Subject: River Bend Station  
Docket No. 50-458  
License No. NPF-47  
Additional Information Related to License Amendment  
License Amendment Request (LAR) 99-15, Changes to Technical Specifications  
for Power Uprate of River Bend Station

Response to NRC Questions Related to River Bend Station Power Uprate Amendment

**Enclosure 2**  
**Response to NRC Questions Related to River Bend Station Power Uprate Amendment**  
**(TAC NO.MA6185)**

Summary Of Plots

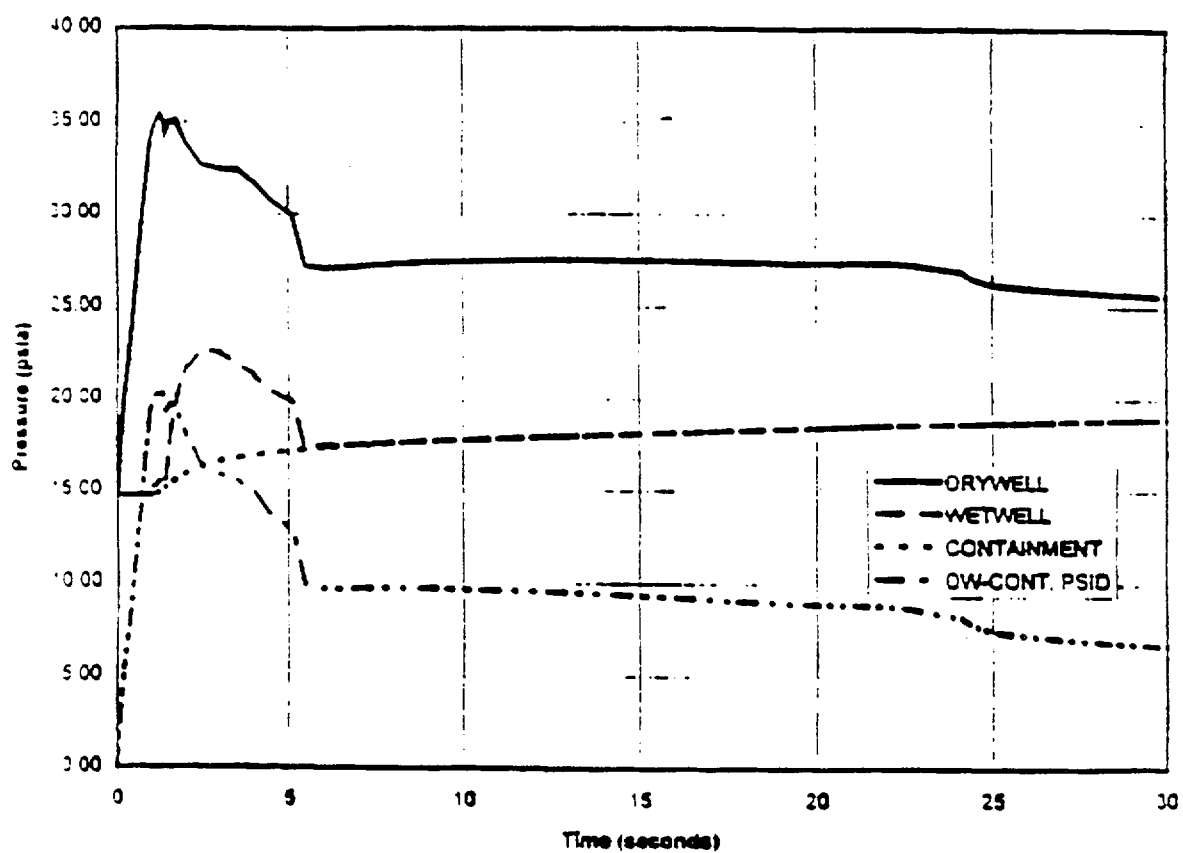
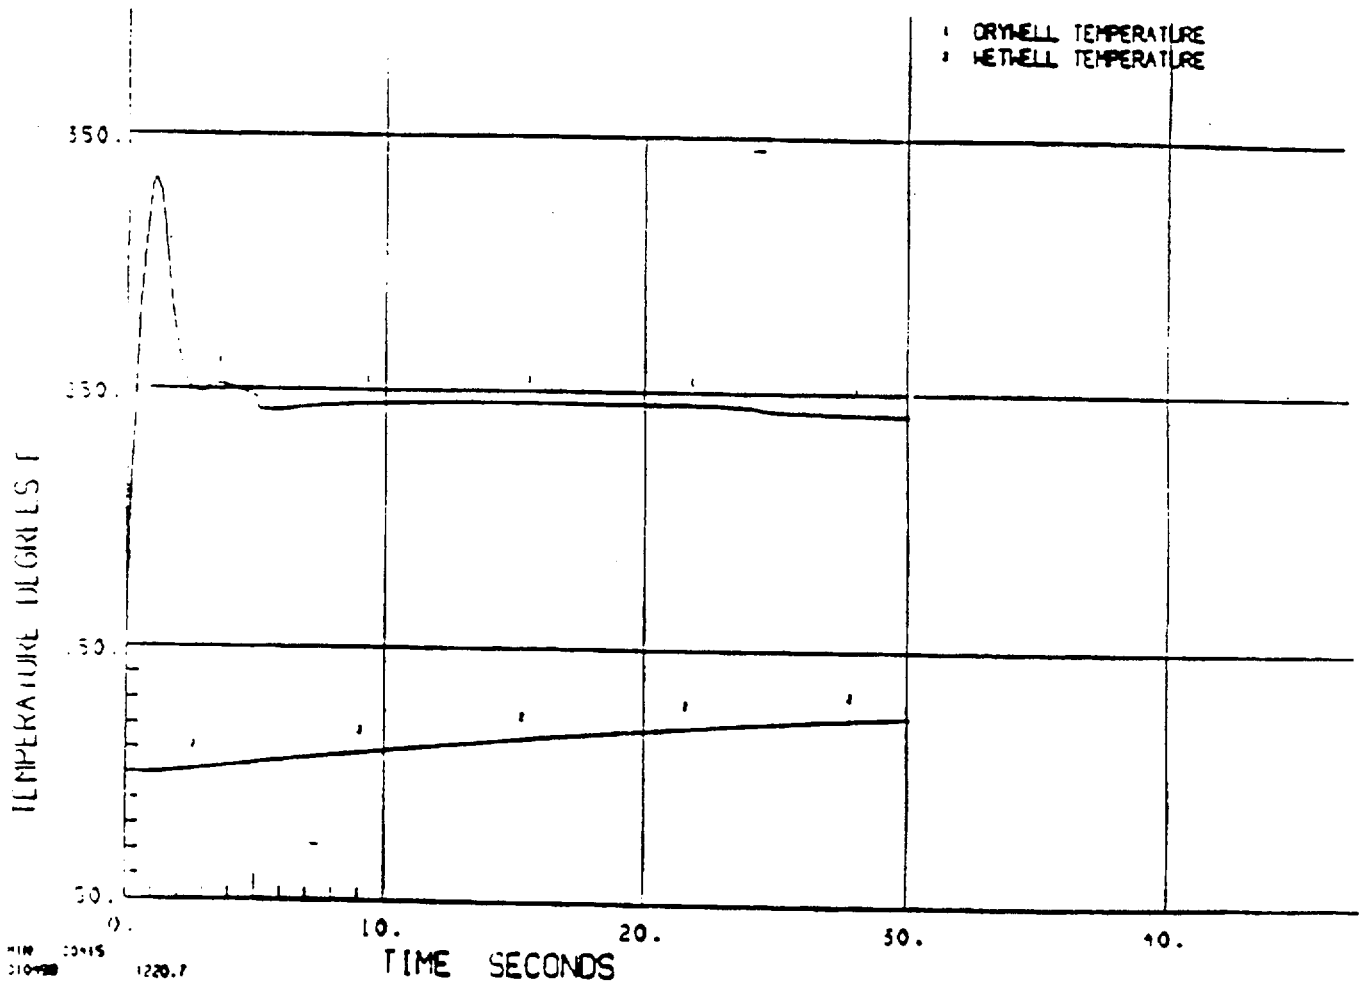
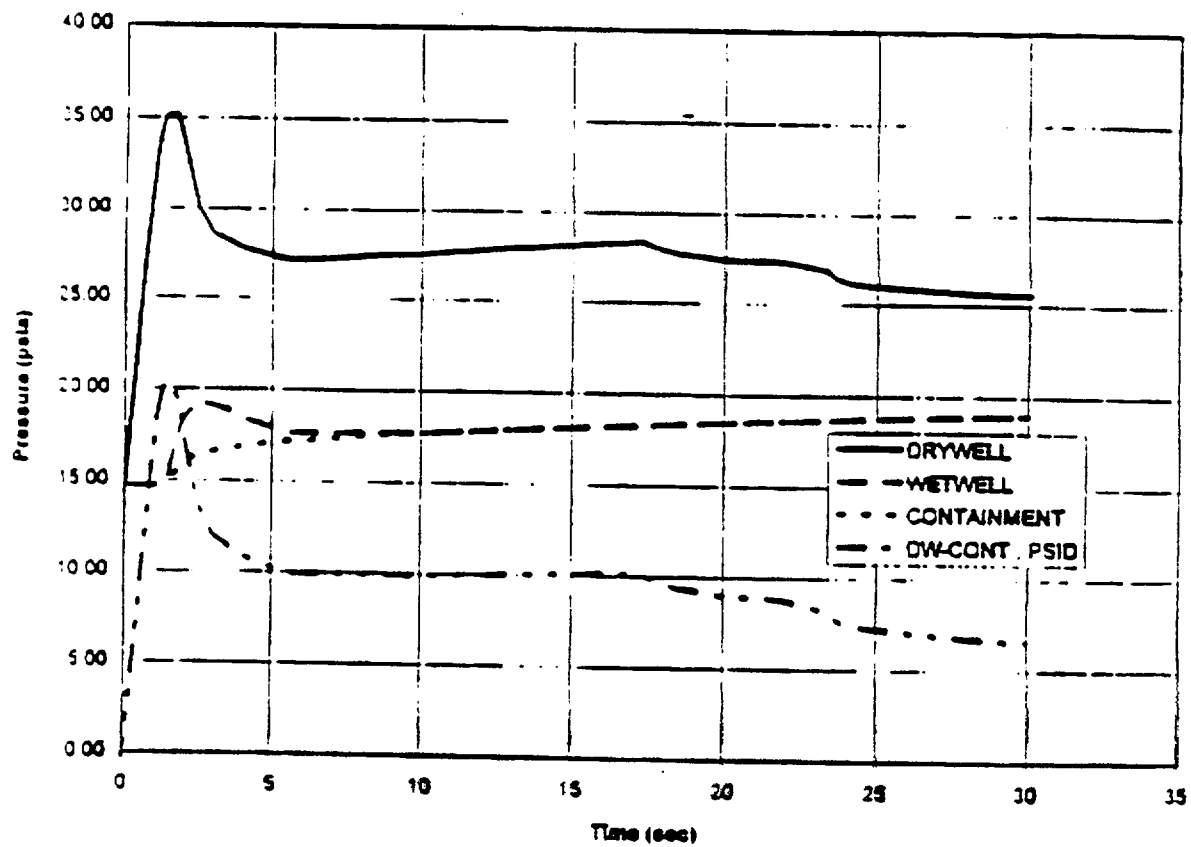
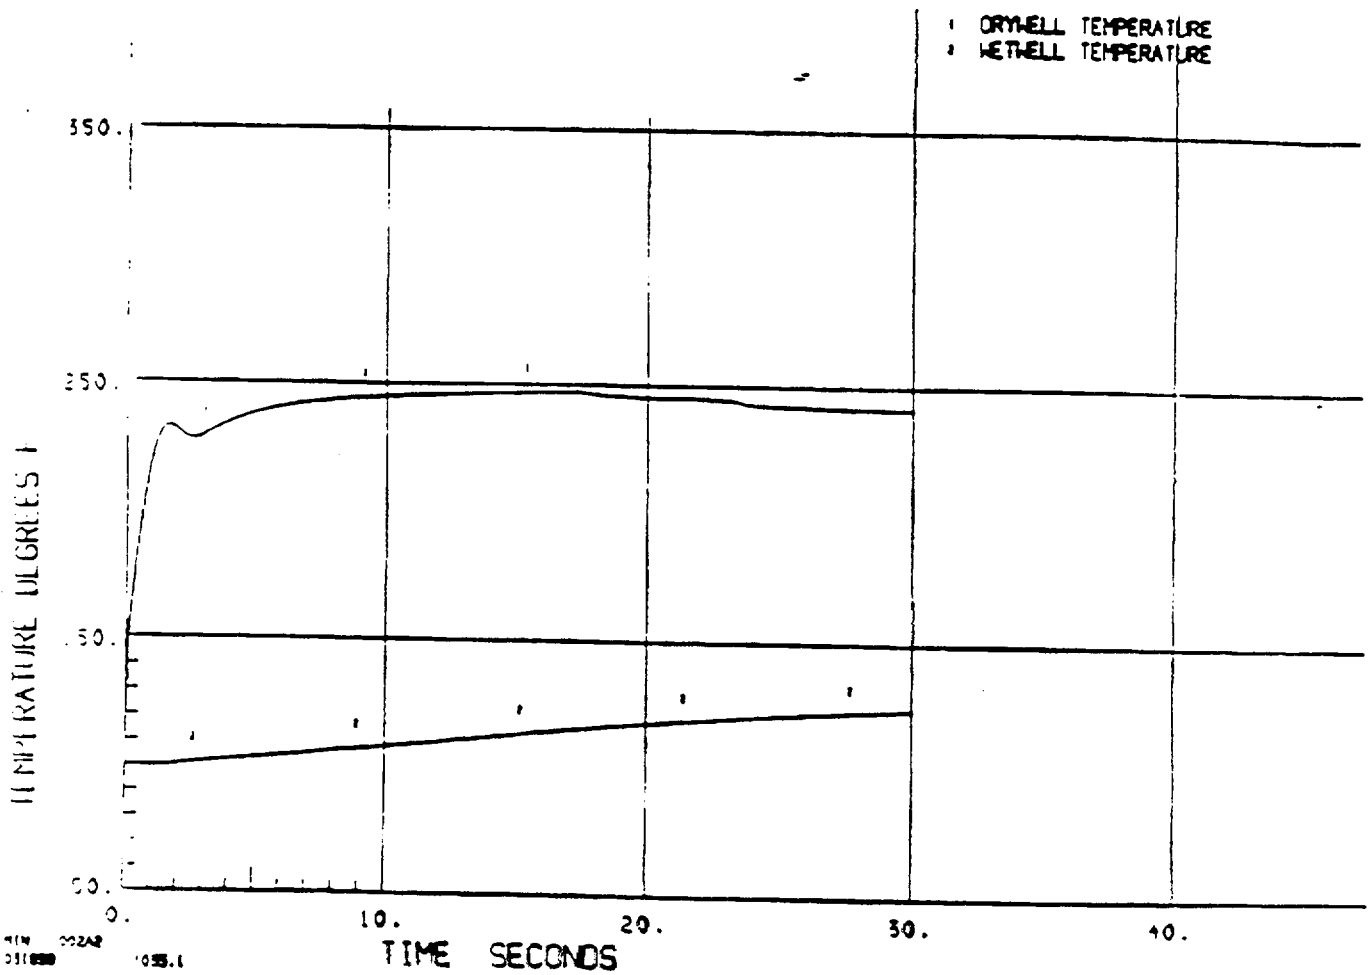
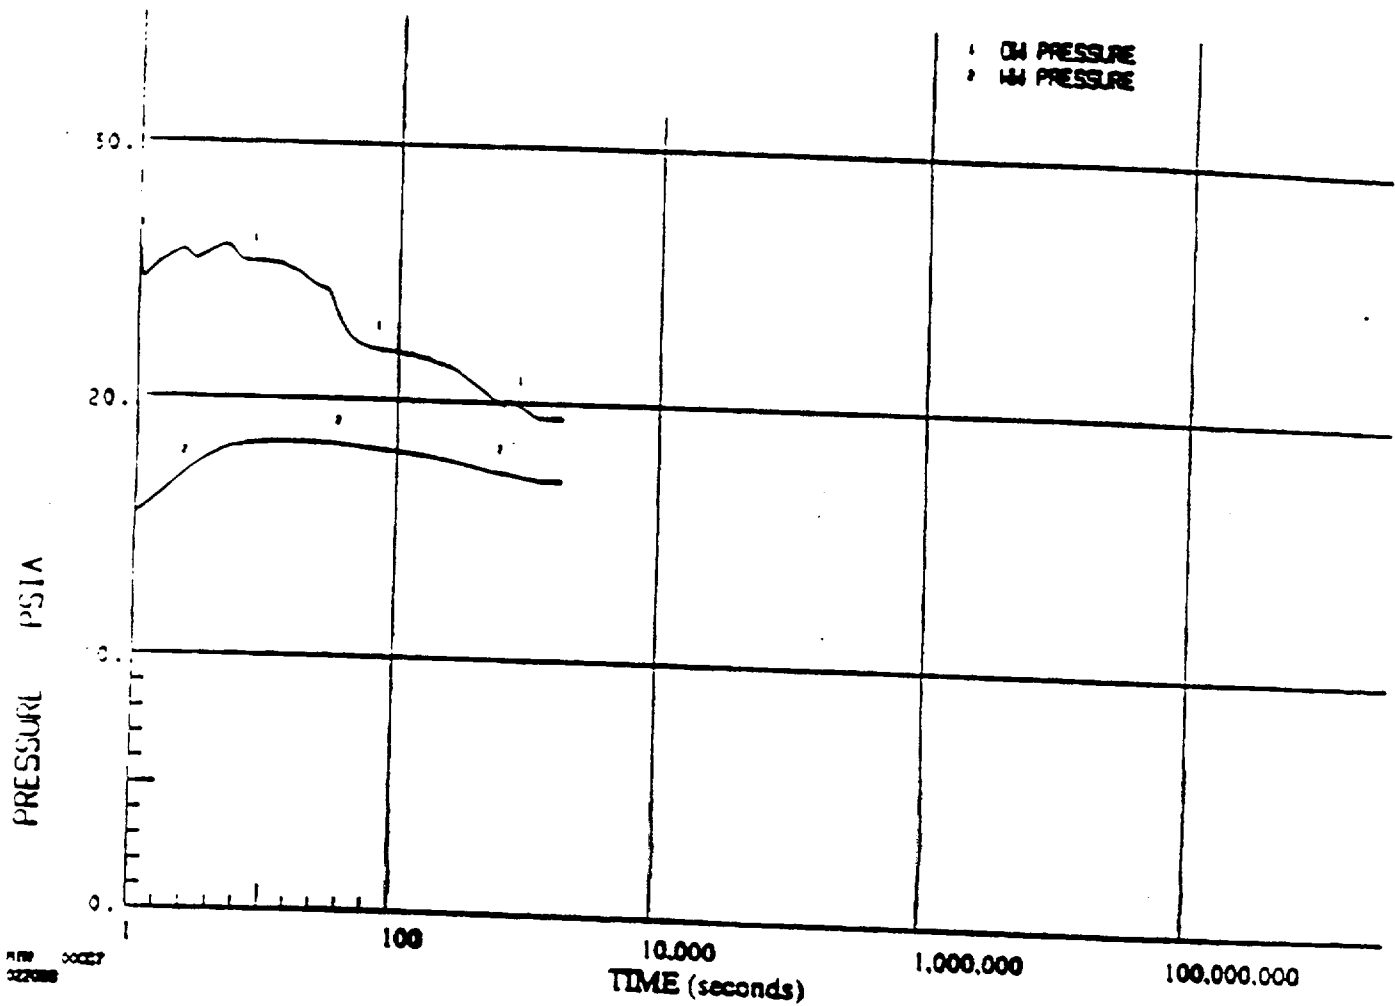
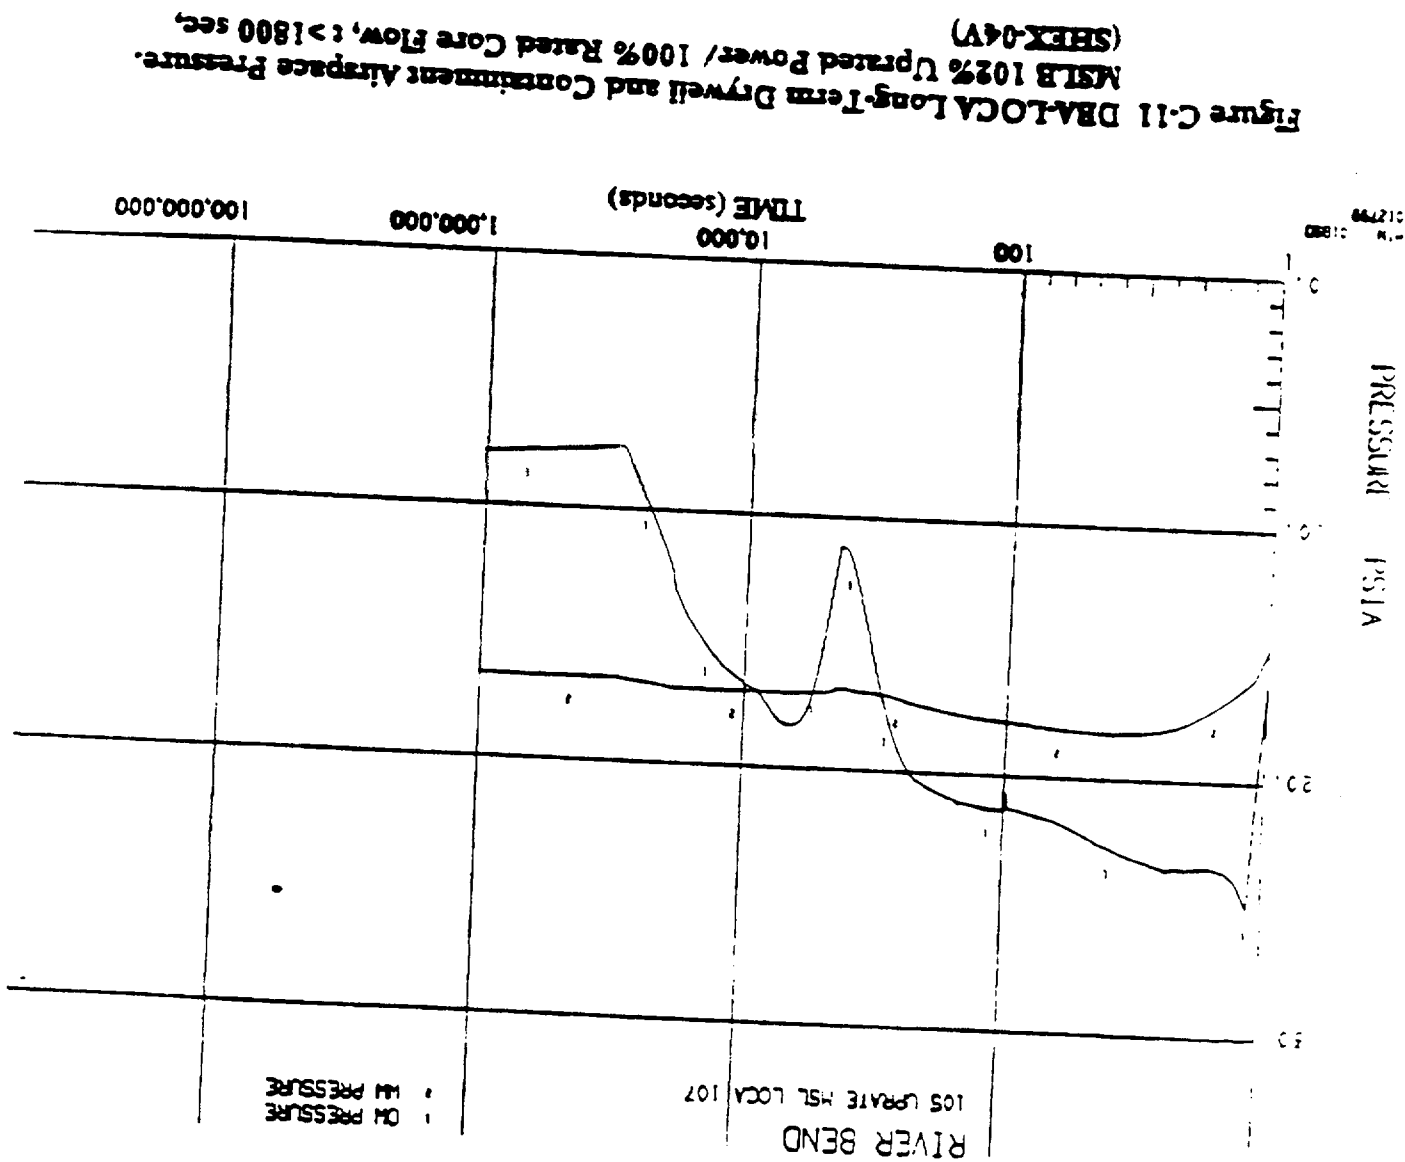
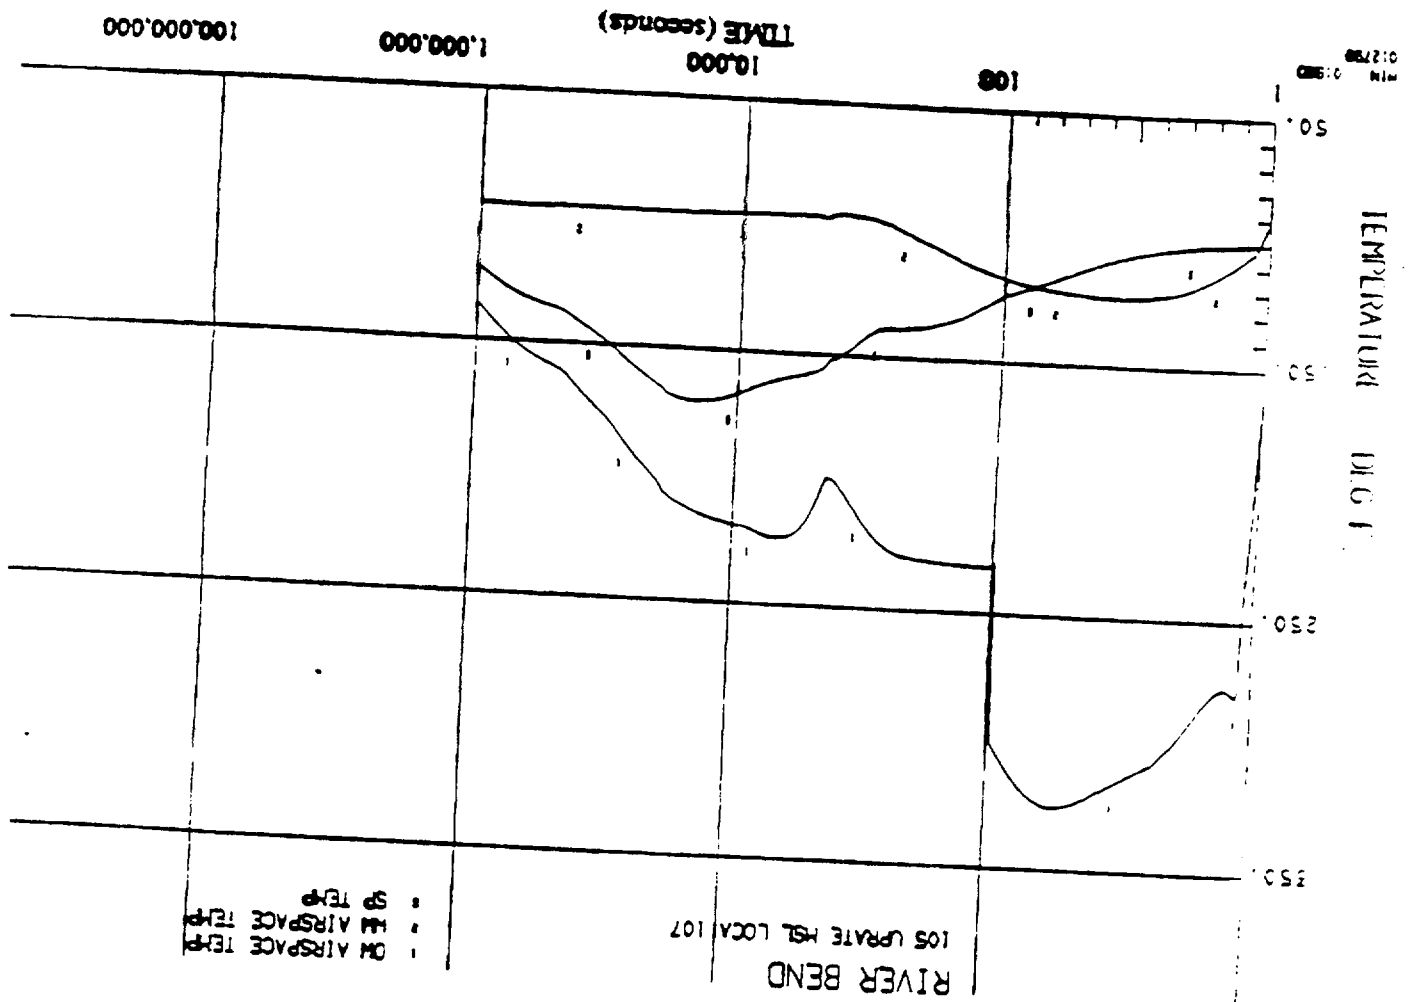
**Question 5:** Please provide the containment analyses maximum pressure and temperature curves at uprated power after a LOCA. Discuss the limiting initial conditions assumed for the DBA LOCA and for the sensitivity case for the MSLB for peak drywell pressure as indicated in Section 4 1.1.3. Also provide the containment drywell pressure limit in psig.

**Response 5:** Drywell & Containment Pressure Temperature Plots are attached at the end of this response. Please note that these figures are considered GE proprietary information. The original USAR analysis was based upon a nominal set of initial conditions. These results were supplemented by a sensitivity analysis to establish the range of acceptable conditions for the containment (Technical Specifications 3.6.1.4, 3.6.1.5, 3.6.2.1, 3.6.5.4, and 3.6.5.5). The following table summarizes the initial conditions, and key results for the nominal case, and significant sensitivities.

*In the table above, the peak drywell temperature is shown to exceed the design limit by approximately 3 °F. This is discussed in Section 4.1.1.3 of NEDC-32778P. The computer program used to calculate the short term response does not include the impact of heat sinks on the temperature rise. If heat sinks are considered, the peak drywell temperature will not exceed 330 °F.*

*The current value of  $P_a$  used for containment testing is 7.6 psig, and is based upon the containment response assuming Technical Specification initial conditions. This value of  $P_a$  bounds the peak containment pressure calculated for uprate. Therefore, the value of  $P_a$  for containment testing will remain 7.6 psig.*
